PORTLAND MAINE

Re: Libbytown Traffic Circulation and Streetscape Study – Sept 23, 2013 Response From
MaineDOT

621727F1

Re: MaineDOT comments on Libbytown Draft Report dated September 23, 2013

Attachment 1: Revised VMT and VHT Tabulations

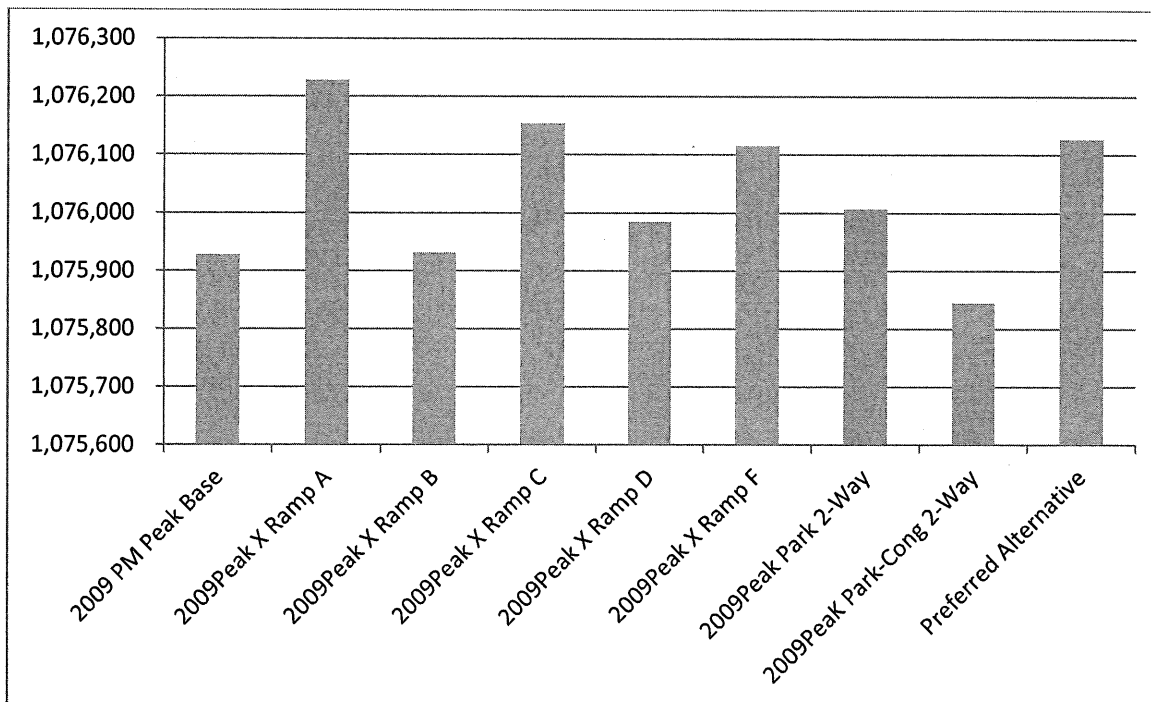
The modeling tabulations in the study indicate both a reduction in Vehicle Miles Traveled (VMT) and Vehicle Hours Traveled (VHT) when the ramps are removed. This scenario is counter-intuitive to removal of roadway network segments, including ramps. MaineDOT findings indicate that the base VMT and VHT modeling tabulations were apparently made with incorrect base information, leading to skewed modeling results. The resulting tabulations apparently overestimated reductions and underestimated increases in travel times and distances. The fundamental reasoning for the recommended alternatives is thus evidently based on flawed data.

The model results of VMT and VHT were not the “fundamental reasoning” for the recommended alternative. Rather, the recommendations were based on the project goals to improve multimodal transportation, livability and economic vibrancy of the study area. The travel demand modeling was conducted to provide supplemental information on the effects that these recommendations would have on the regional transportation network. The PACTS model was significantly enhanced as part of this work so that it better reflects the complexity and multimodal patterns currently observed in Portland. Using the enhanced model, the ramp removals and two-way street conversions were tested, as were the alternative scenarios that included various combinations of ramp removals and two-way conversions. The Draft report contained erroneous VMT and VHT base volumes in several tables, and this will be corrected in the final report. The corrected tabulations show that the reports recommended alternative will have a very minor increase of 0.2% in VMT, a small reduction of 0.01% in VHT. However, to reiterate, our recommendations were not based on model results, but rather were based on design recommendations to meet the project's primary goals. Revised VMT and VHT results are attached to this letter, and will be included in the final report.

The following table and graph are revised to reflect the correct base VMT data. .

These show that most of the study recommendations would individually result in small increases of regional vehicle-miles-traveled, with the exception of converting both Park and Congress to two-way streets, which results in a small reduction. The preferred alternative is modeled to increase regional VMT by 0.019%, which is very small given the accuracy of the model.

Attachment 2: HCL Analysis

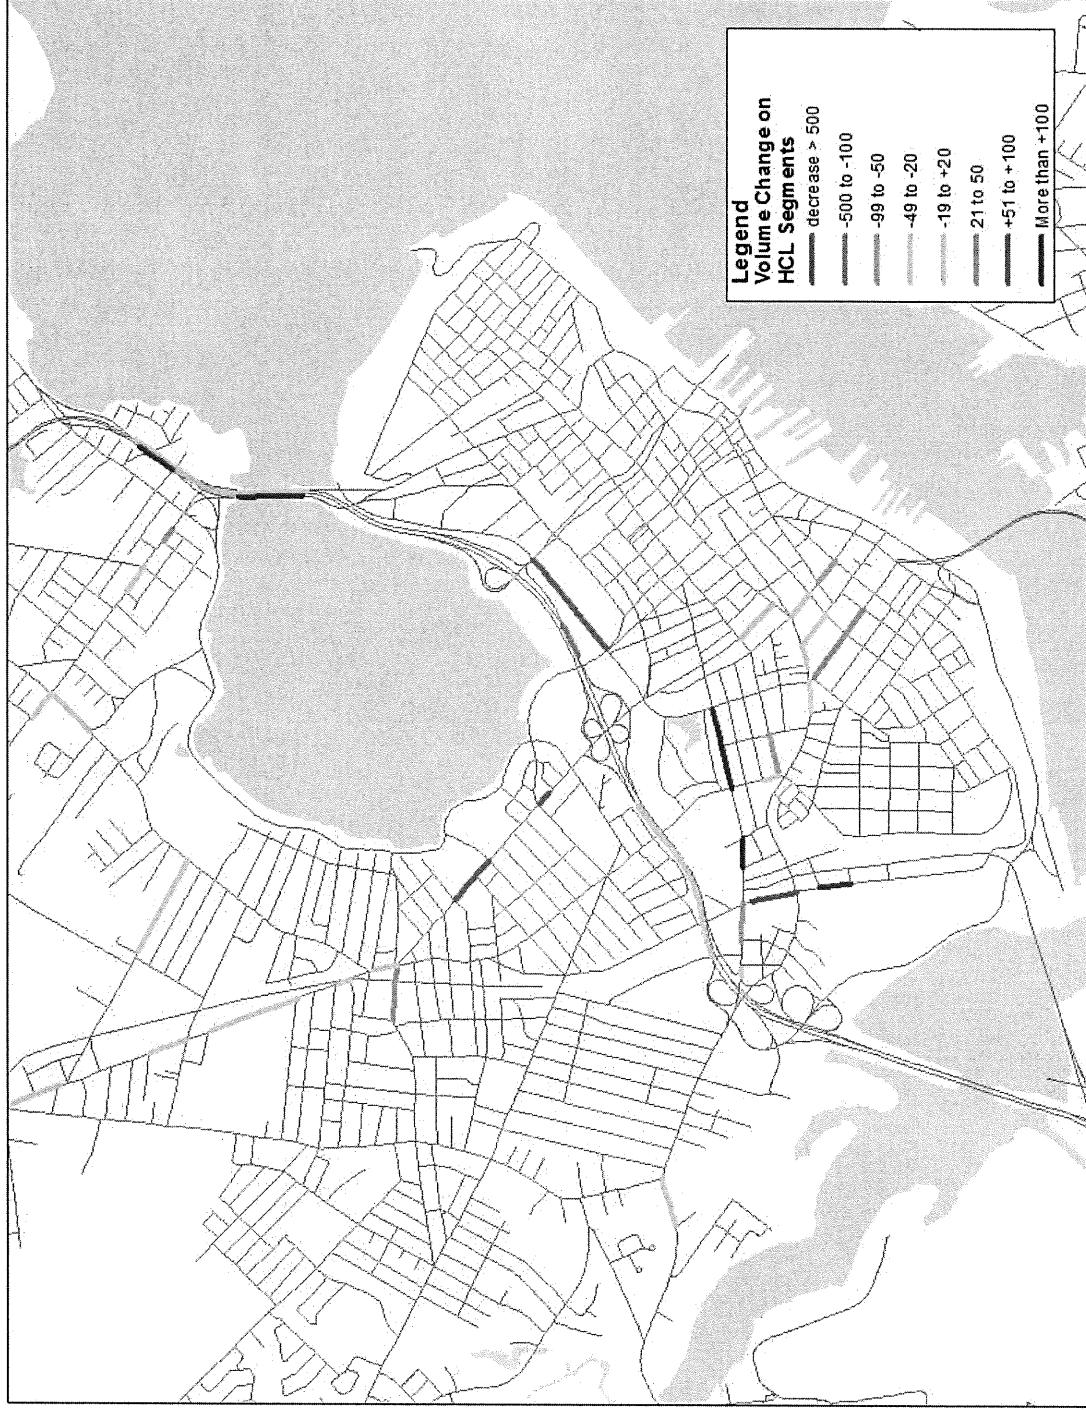
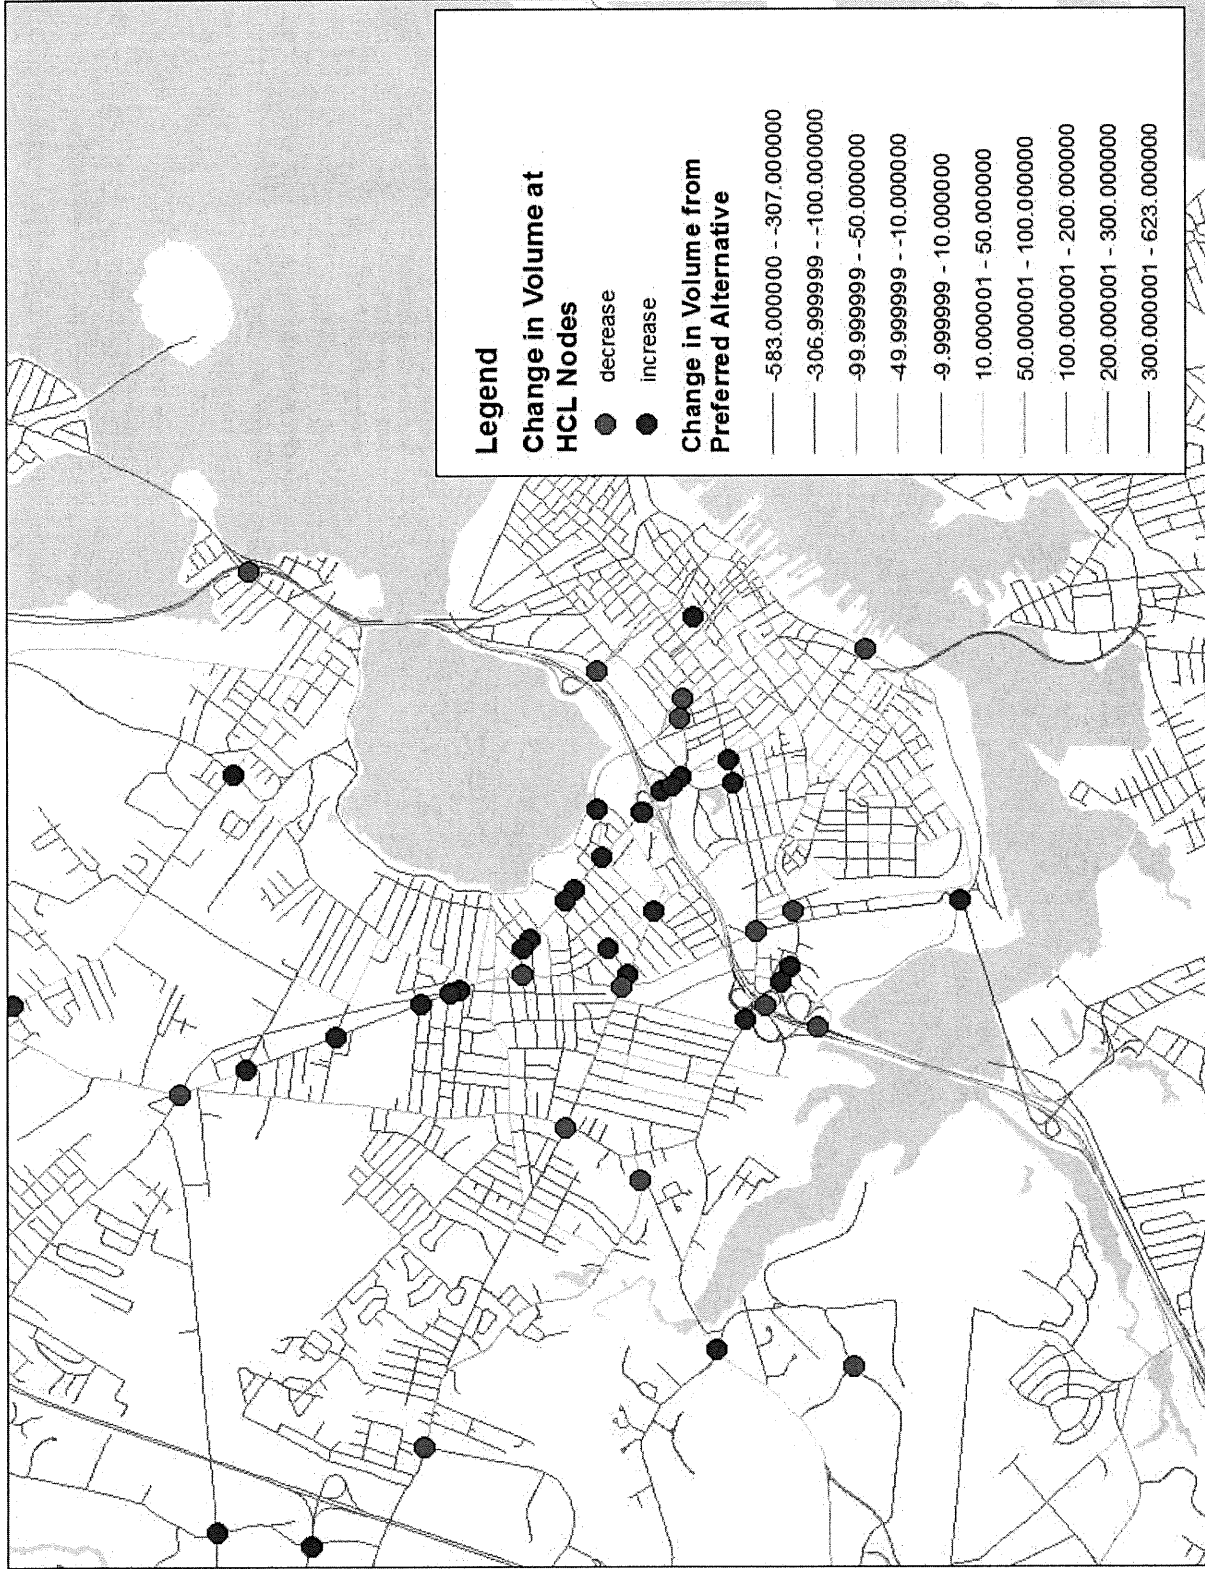
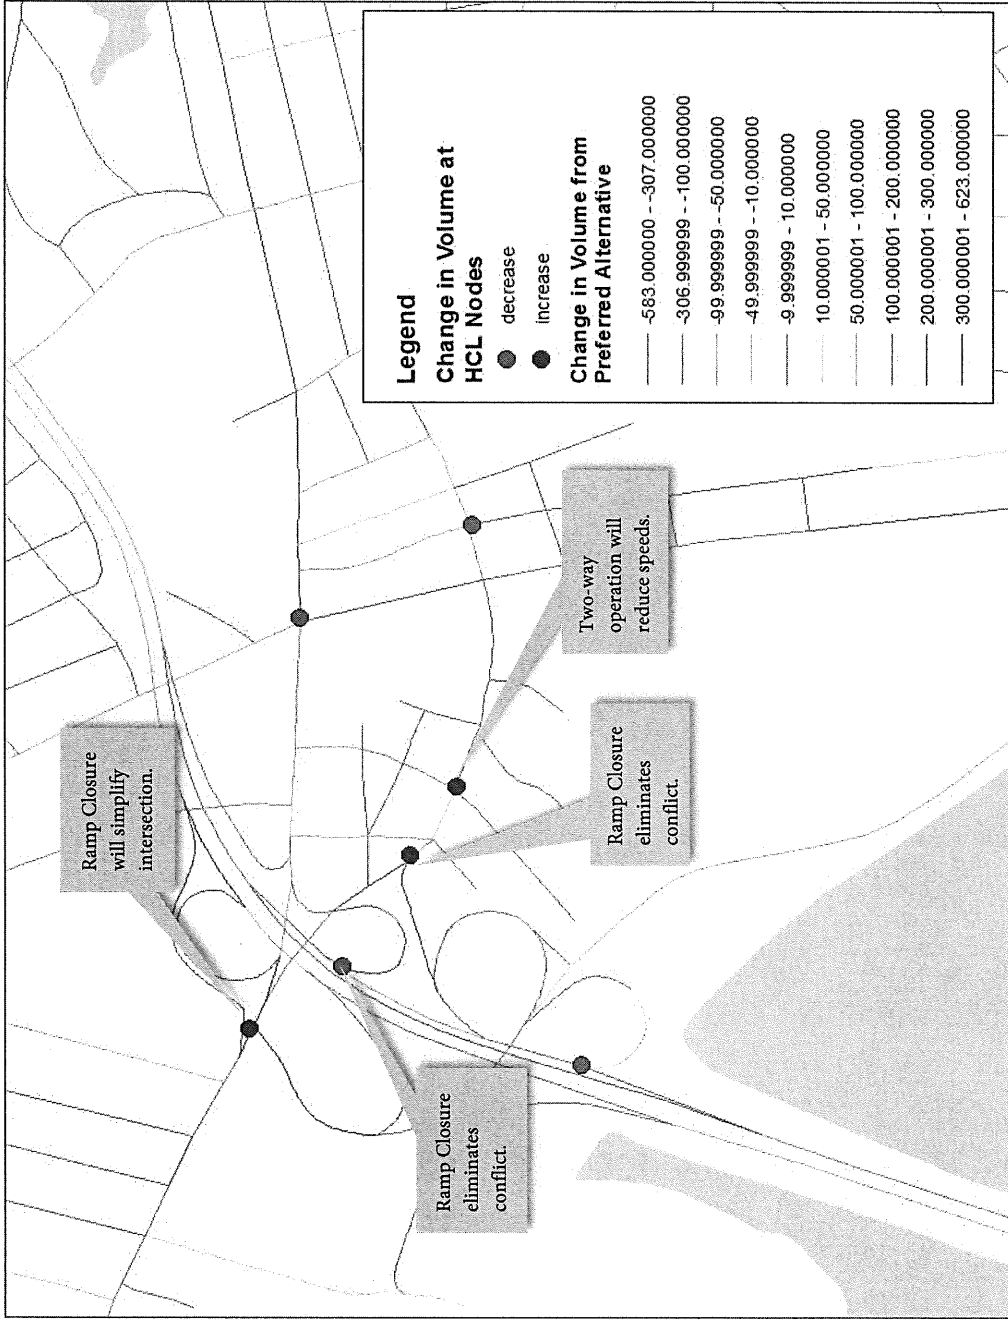
MaineDOT and FHWA are very concerned about the potential increase in crashes at the remaining ramps that will see increased use. The Fore River Parkway northbound on-ramp is an existing high crash location, and the proposed removal of Ramp C would increase the volume of traffic on the weave of the I-295 collector-distributor. MaineDOT has serious concerns about the potential for increased crashes at this location.

Safety for all users should be the highest priority when considering the alternatives, and was a primary factor in the development of the study recommendations. The removal of ramps will essentially eliminate a number of existing high crash locations, although some other high crash locations may see increases in volume. In regards to the Fore River Parkway northbound on-ramp, the model shows an overall decrease in volume, not an increase as asserted by MaineDOT. The model shows that the on-ramp will increase, but the collector-distributor decreases by a larger amount, such that the volume in the weave section, which is also a high crash location, decreases. More details on how the report recommendations could affect HCLs are attached to this letter.

The following figure shows the projected modeled traffic volume changes on HCL road segments. Segments in shades of green and yellow will have decreases in volumes, and segments with orange and red will have increases in volumes.

The following figure shows HCL nodes that our preliminary analysis indicates will see increase (red) or decreases (green) in modeled traffic volumes.

The following figure provides the same information, but focused on the study area. Of particular note is that the HCL that is located at the merge point of the I-295 northbound on ramp from Fore River Parkway will actually see a decrease in volume. The model shows a higher volume on the ramp, but lower volumes on the Collector-distributor more than compensate, so that this HCL node has an overall decrease in volume.

While a conclusive analysis of all of these locations is not within our current scope, this screening analysis indicates that there will be mixed effects on volumes at HCL nodes. In particular, the model results indicate that the Fore River Parkway on-ramp would have lower overall volumes due to lower collector-distributor volumes. It is recommended that a more detailed analysis of the effects of traffic changes on HCL locations be conducted as further implementation steps are undertaken.

Attachment 3: Base year LOS Analysis

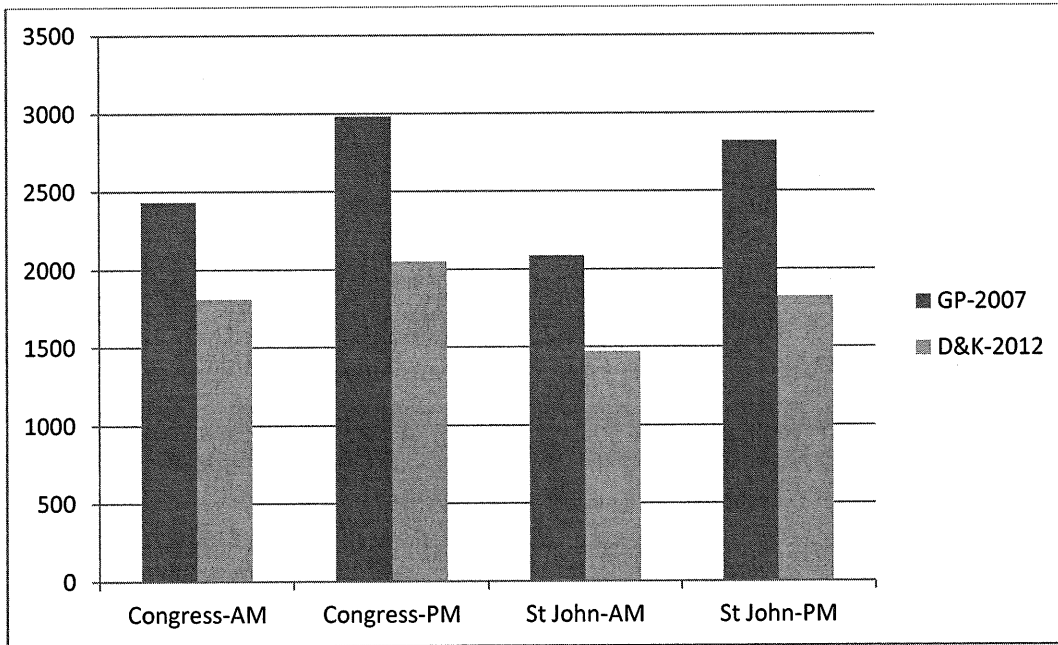
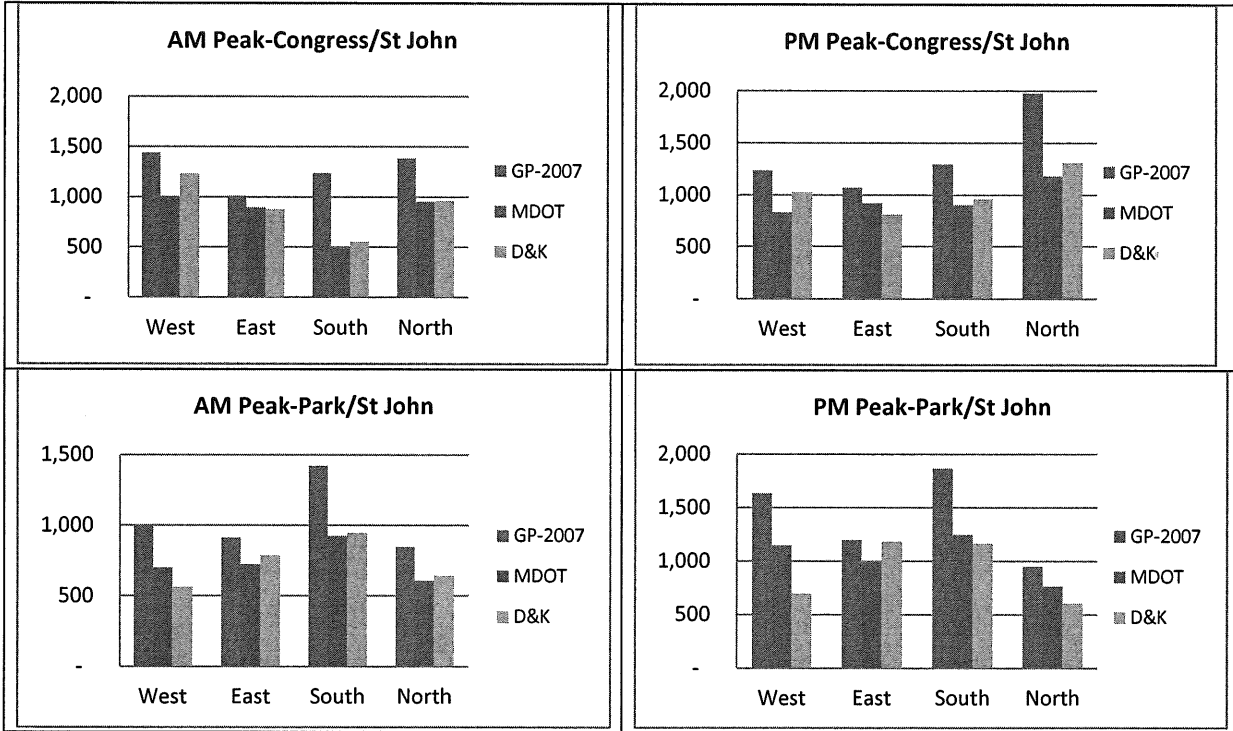
The intersections of St. John Street and Congress Street, and St. John Street and Park Avenue were rated at a LOS A in the report, while an independent analysis on an existing transportation improvement project indicates that these intersections are currently functioning at LOS C or D. Since these intersections are part of the Synchro network used for modeling, and since the study data related to these intersections in the report do not match existing data, we are not confident that the entire network model is calibrated properly. In addition, the LOS at some other intersections does not match actual conditions on the ground.

The Synchro results cited in the report utilized incorrect assumptions on the intersection signals current phasing and timing pattern. This will be corrected in the final report. Our revised analysis indicates that the AM and PM peak hour LOS is C for both intersections, which is consistent with other recent studies. Our results for other intersections, including the Fore River Parkway/Congress and Fore River Parkway/Thompson's Point analyses are consistent with recent independent studies of these intersections associated with the Thompson's Point development. We conducted the Synchro analysis following the

The levels of service for the a.m. and p.m. peak hour were recalculated for the intersections of Congress-St. John and Park-St. John with signal timing and phasing that more closely reflects existing operations. It should be noted that our investigation of traffic counts and trends shows that traffic has declined at these intersections since the construction of the Fore River Parkway, as shown in the charts below.

The revised level of service results for the base year are summarized below and attached to this document. The primary changes were related to signal phasing.
